From: Lasley, Timothy G
Sent: Wednesday, May 23, 2018 11:41 AM
To: 'crys@woodardproperties.com'
Cc: Werner, Jeffrey B; Mess, Camie
Subject: BAR Actions - May 15, 2018 - 517 Ridge Street

Certificate of Appropriateness

BAR 18-05-01
517 Ridge Street
Tax Parcel 290145000
Dogwood Properties LLC, Owners/Applicant
Proposed concrete sidewalk on the front and north side of the property

**CITY OF CHARLOTTESVILLE
BOARD OF ARCHITECTURAL REVIEW
STAFF REPORT
May 15, 2017**

517 Ridge Street—Proposed concrete sidewalk at front and north side.

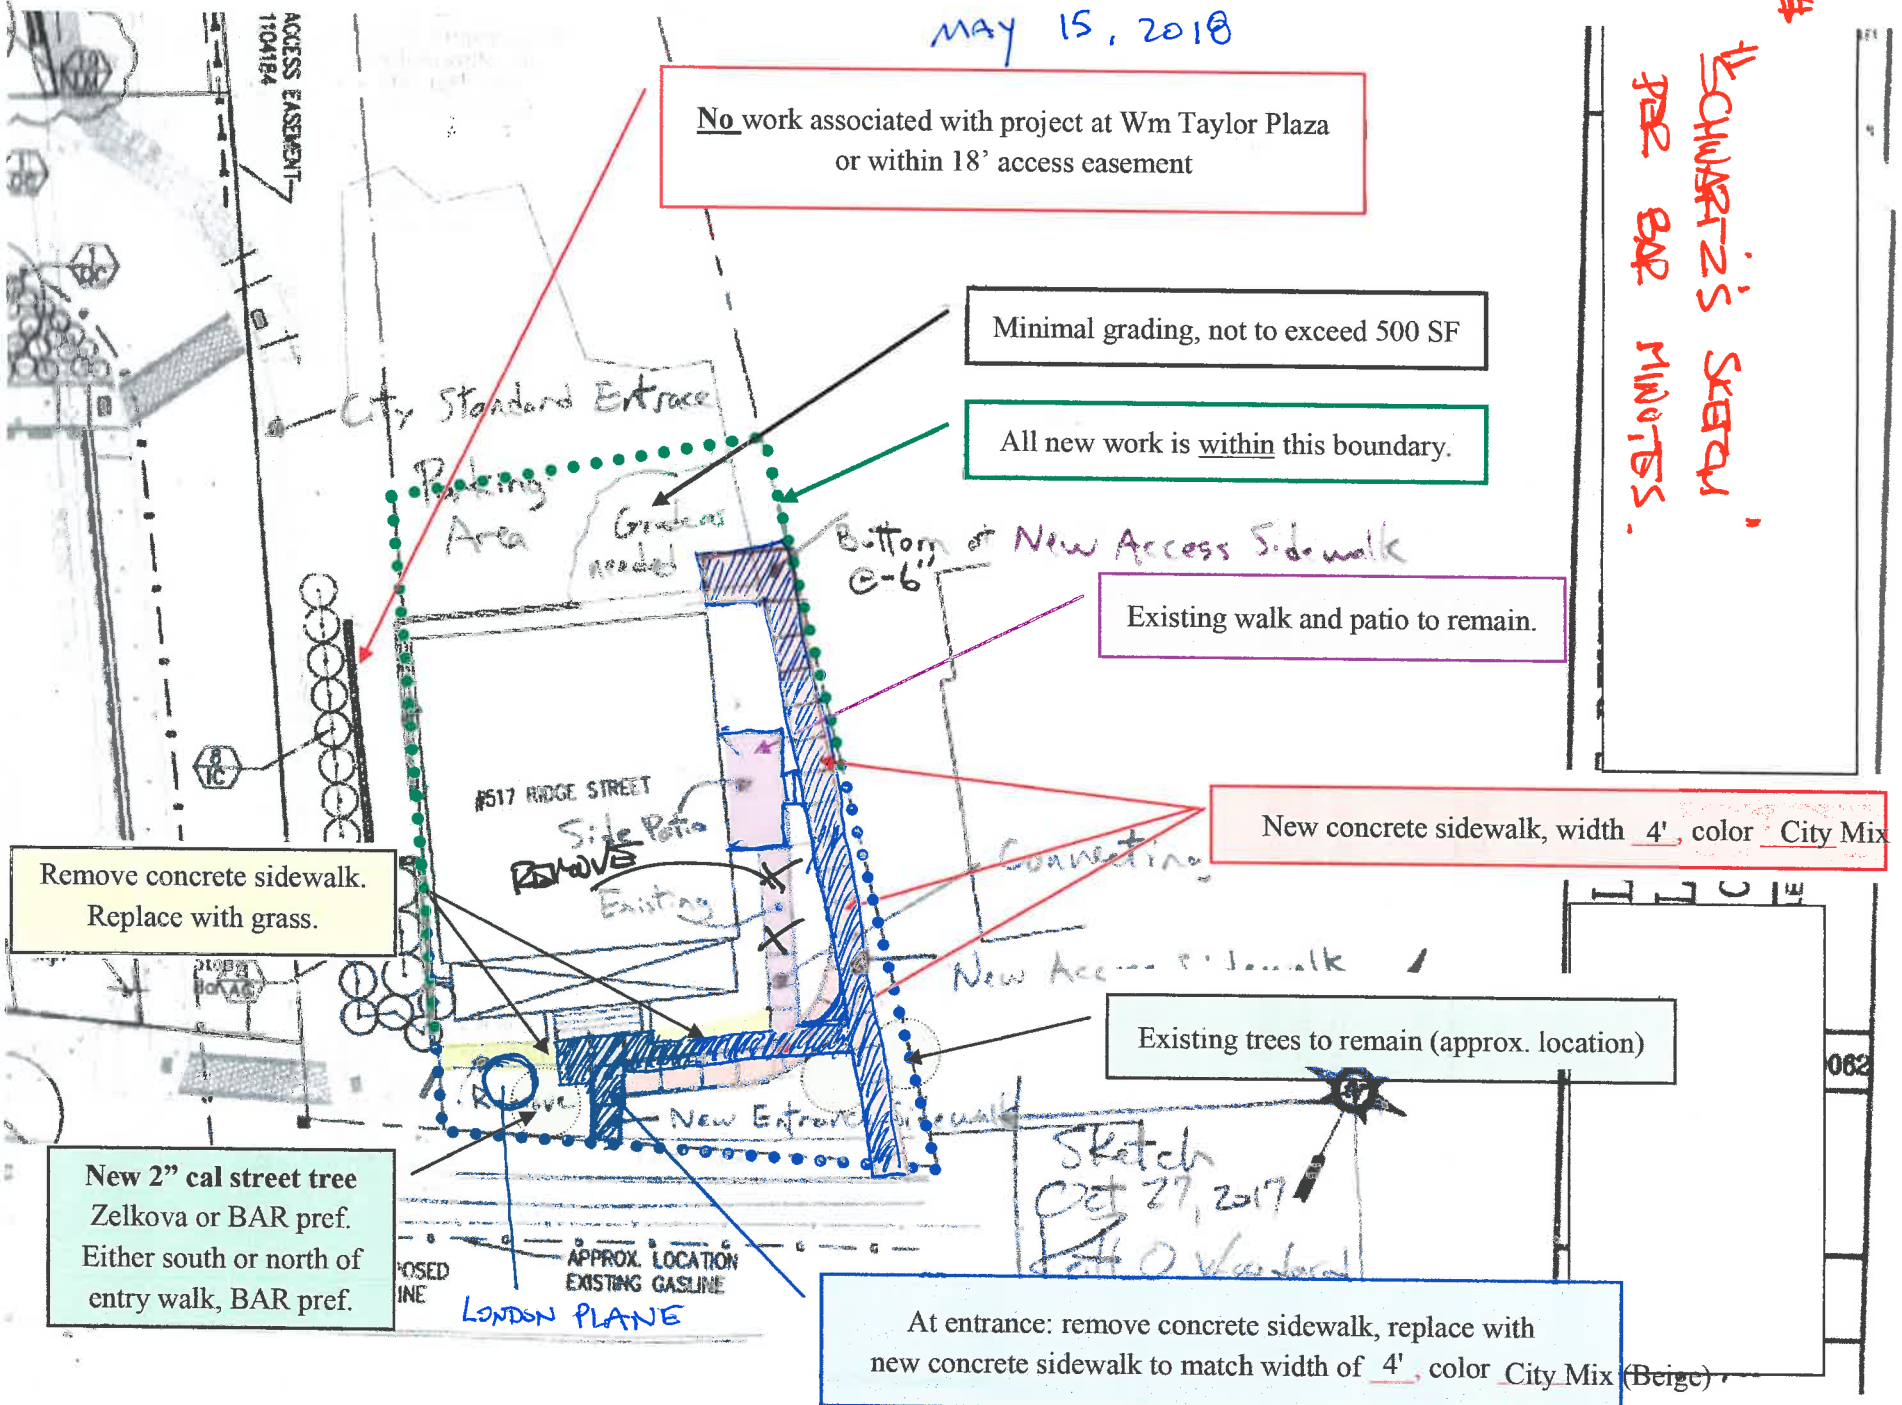
Motion: Schwarz moved having considered the standards set forth within the City Code, including City Design Guidelines for Site Elements and Design, I move to find that the proposed concrete sidewalk satisfies the BAR's criteria and guidelines and is compatible with this property and other properties in the Ridge Street ADC District, and that the BAR approves the application with the following modifications as outlined in Schwarz's sketch dated 5/15/2018. Also, the tree should be centered in the green space, and the BAR is recommending a London Plane. Balut seconded. Approved (6-0).

SKETCH NOTED ON
MAY 15, 2018

SCHWARTZ'S SKETCH
PER BAR MINUTES.

517 Ridge Street—Proposed concrete sidewalk at front and north side.

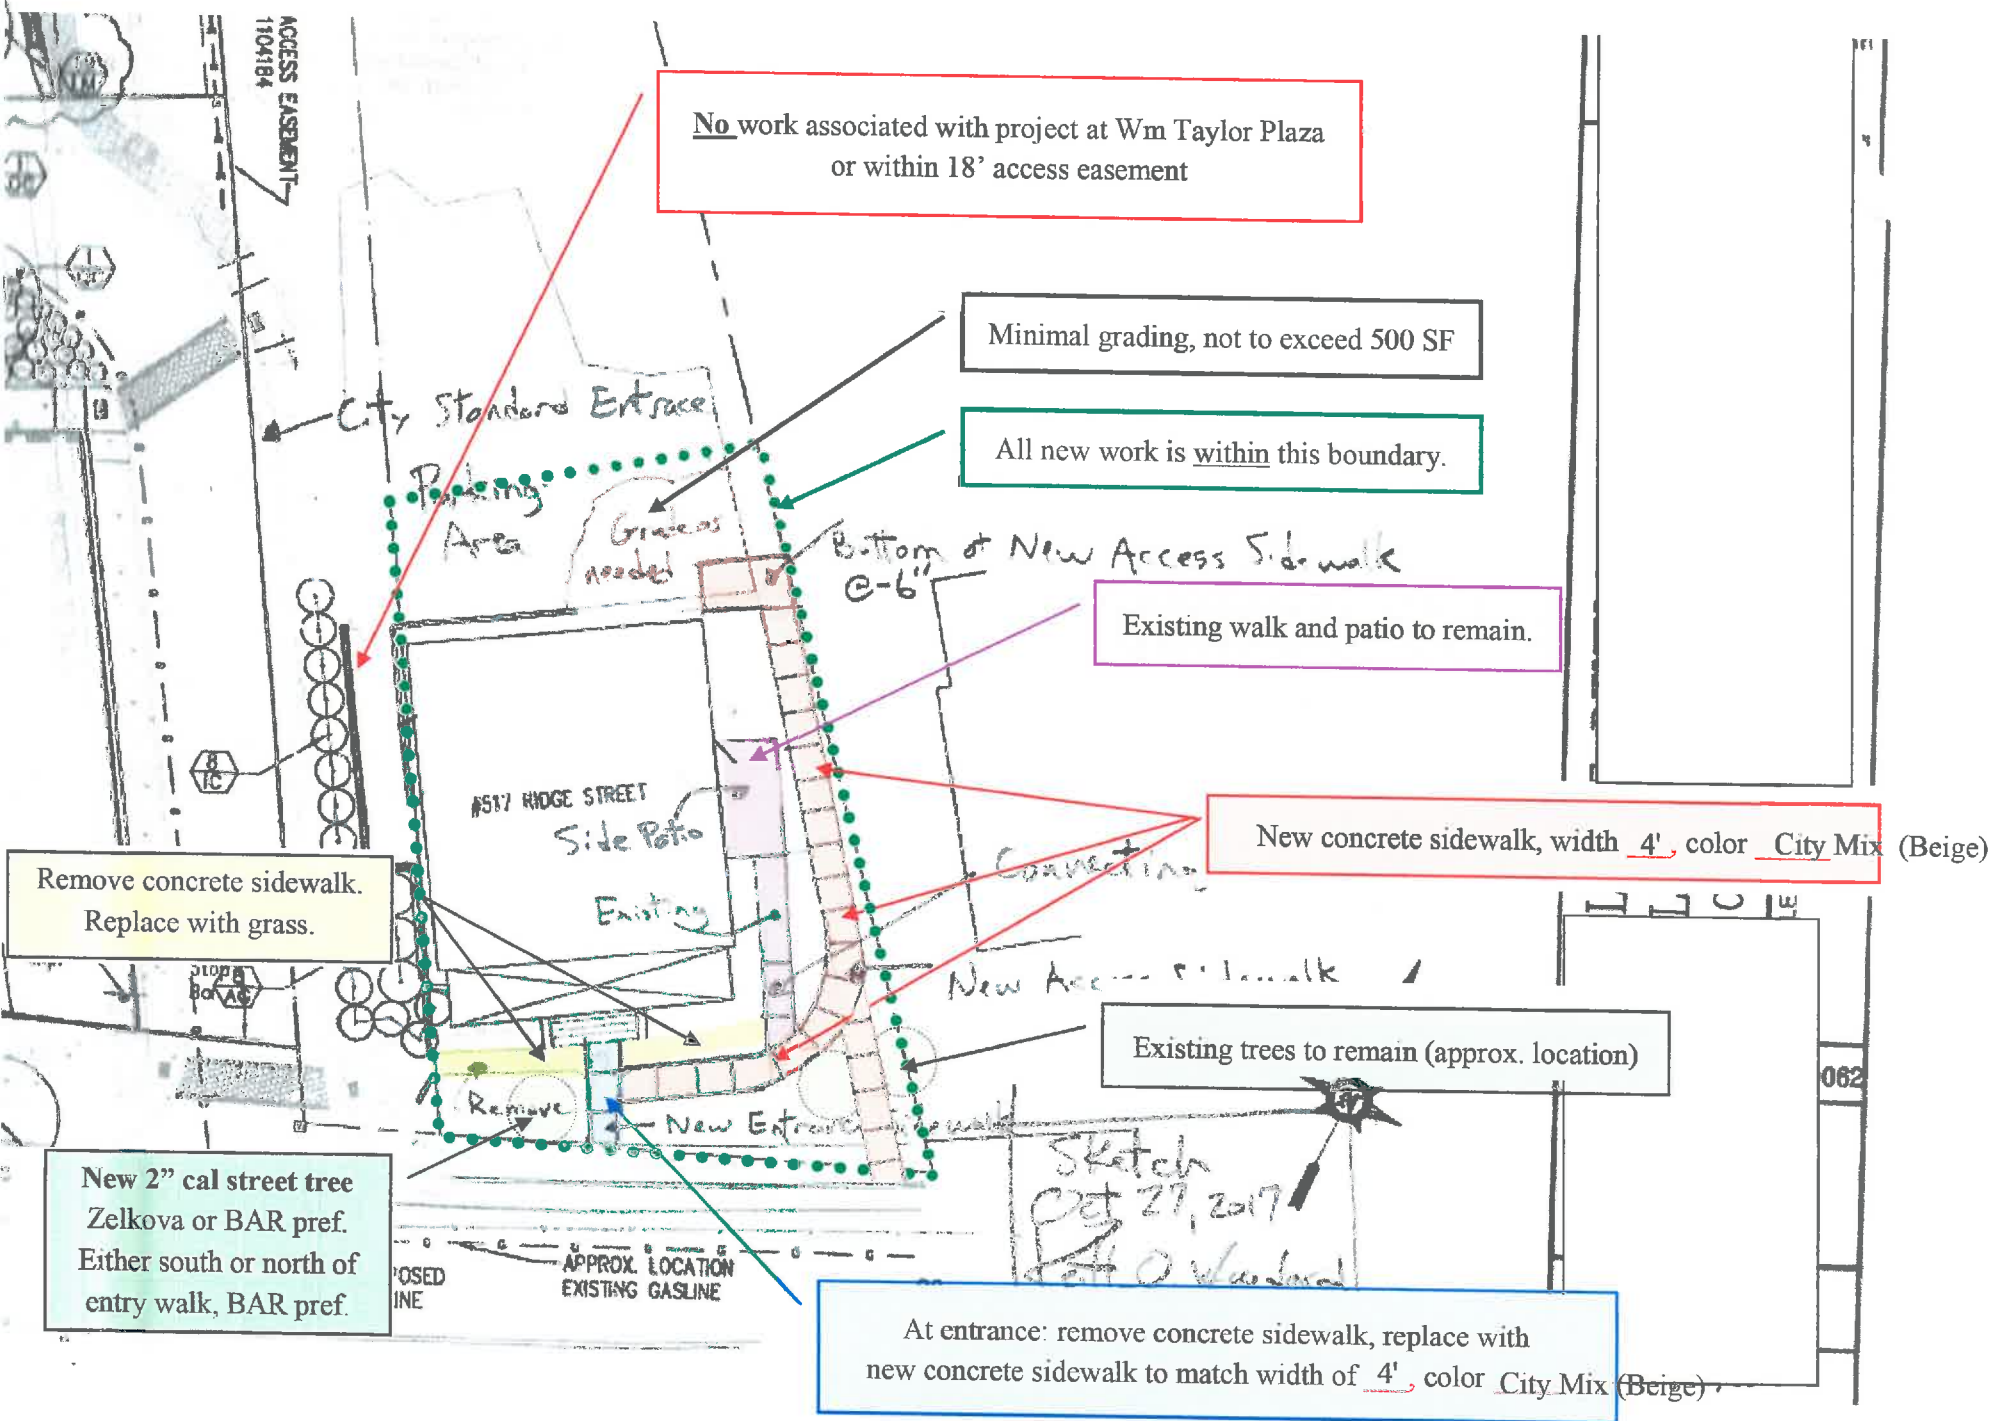
The proposed sidewalk does not significantly visually impact the view of the house from the street and is in compliance with the ADC Guidelines.

The BAR may want to comment on the tree species selected and the proposed location.

517 Ridge Street—Proposed concrete sidewalk at front and north side.

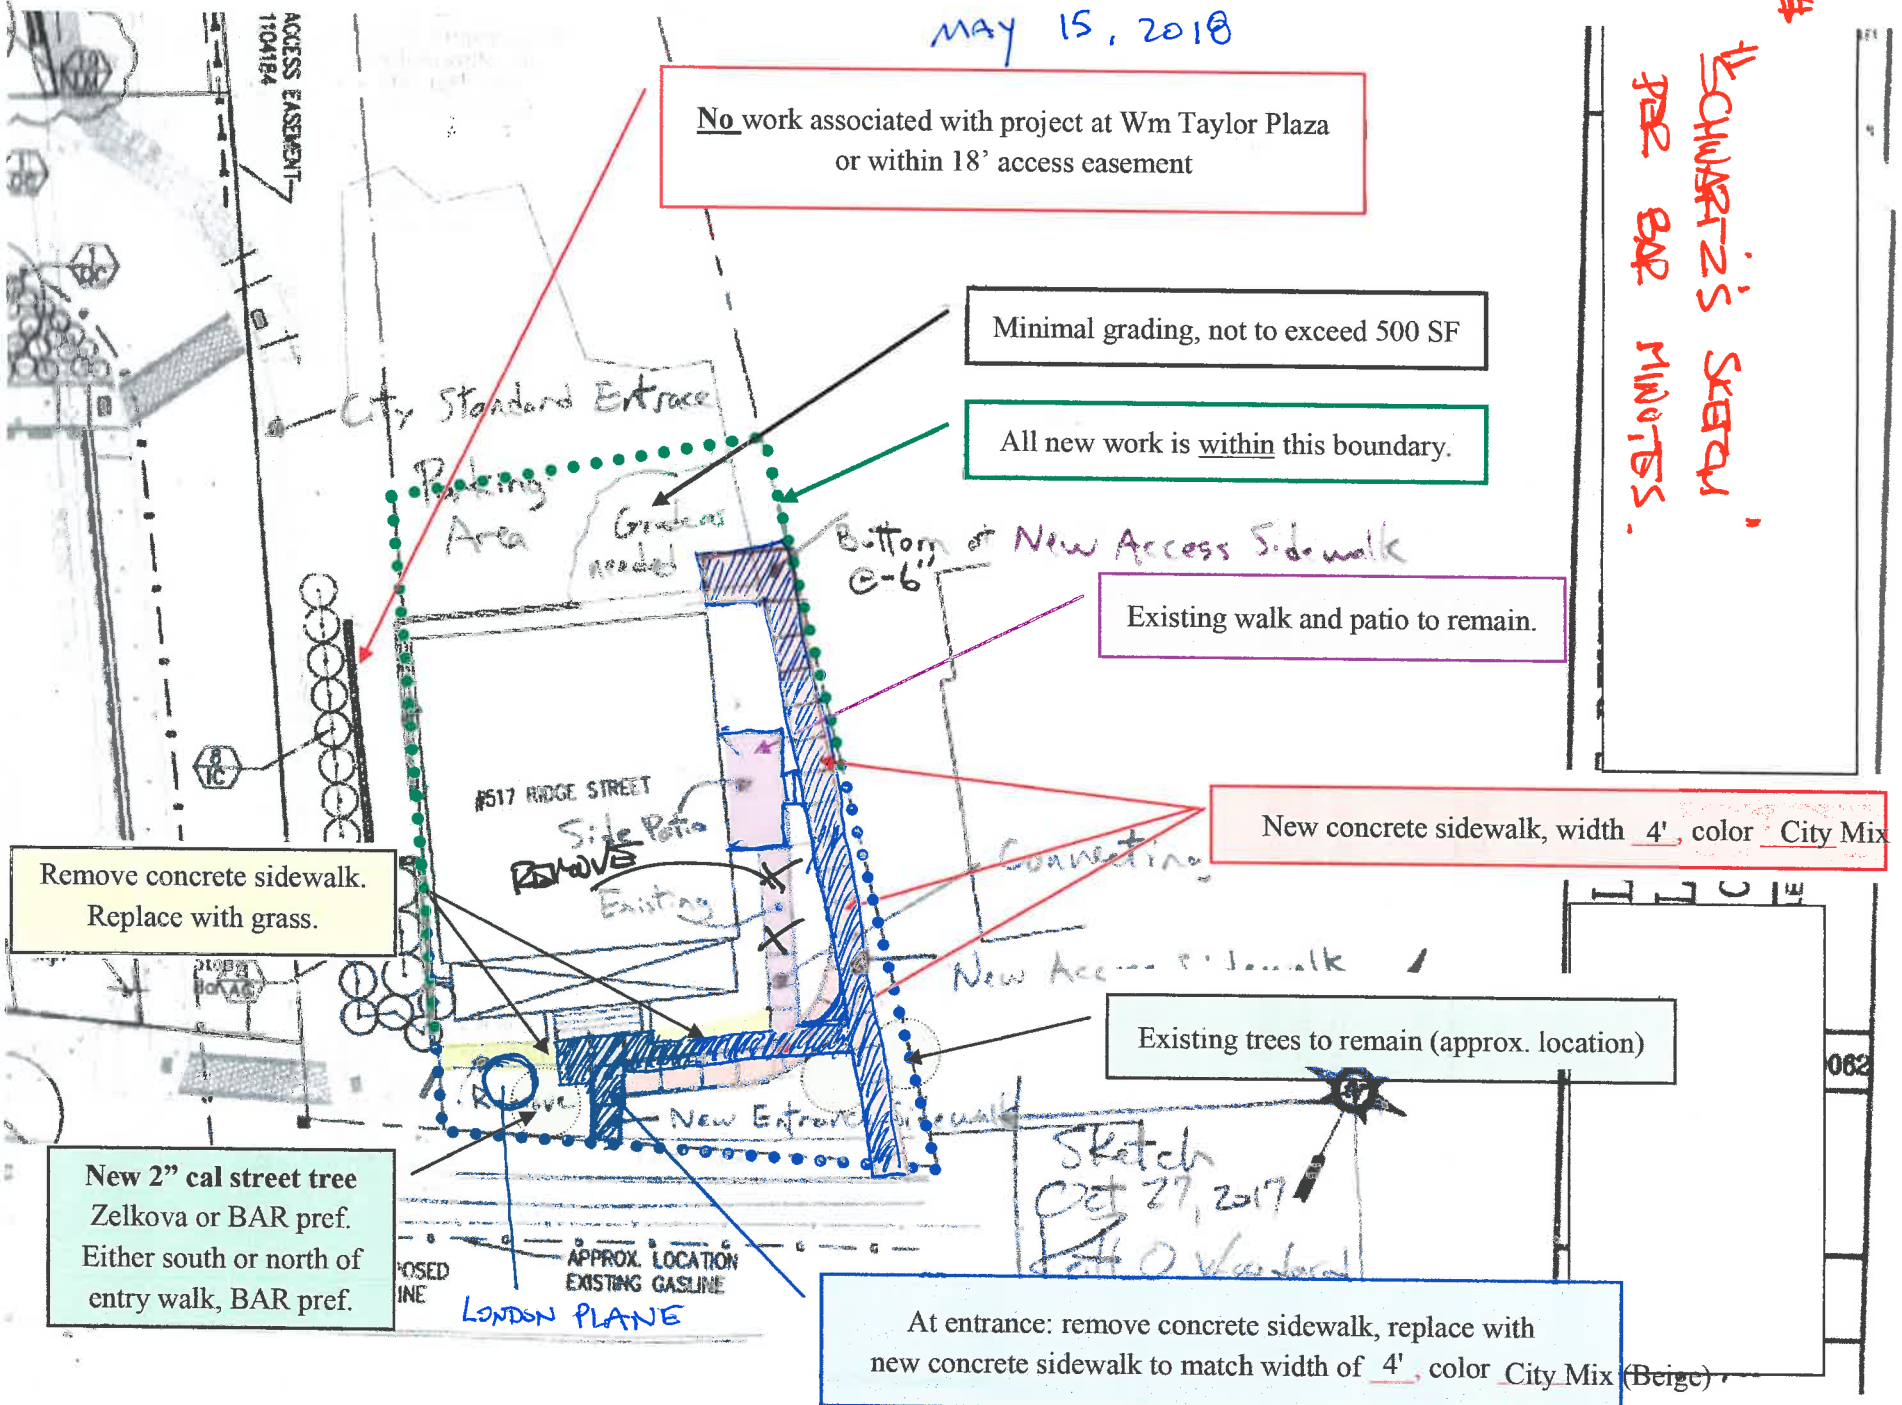
SKETCH NOTED ON
MAY 15, 2018

SCHWARTZ'S SKETCH
PER BAR MINUTES.
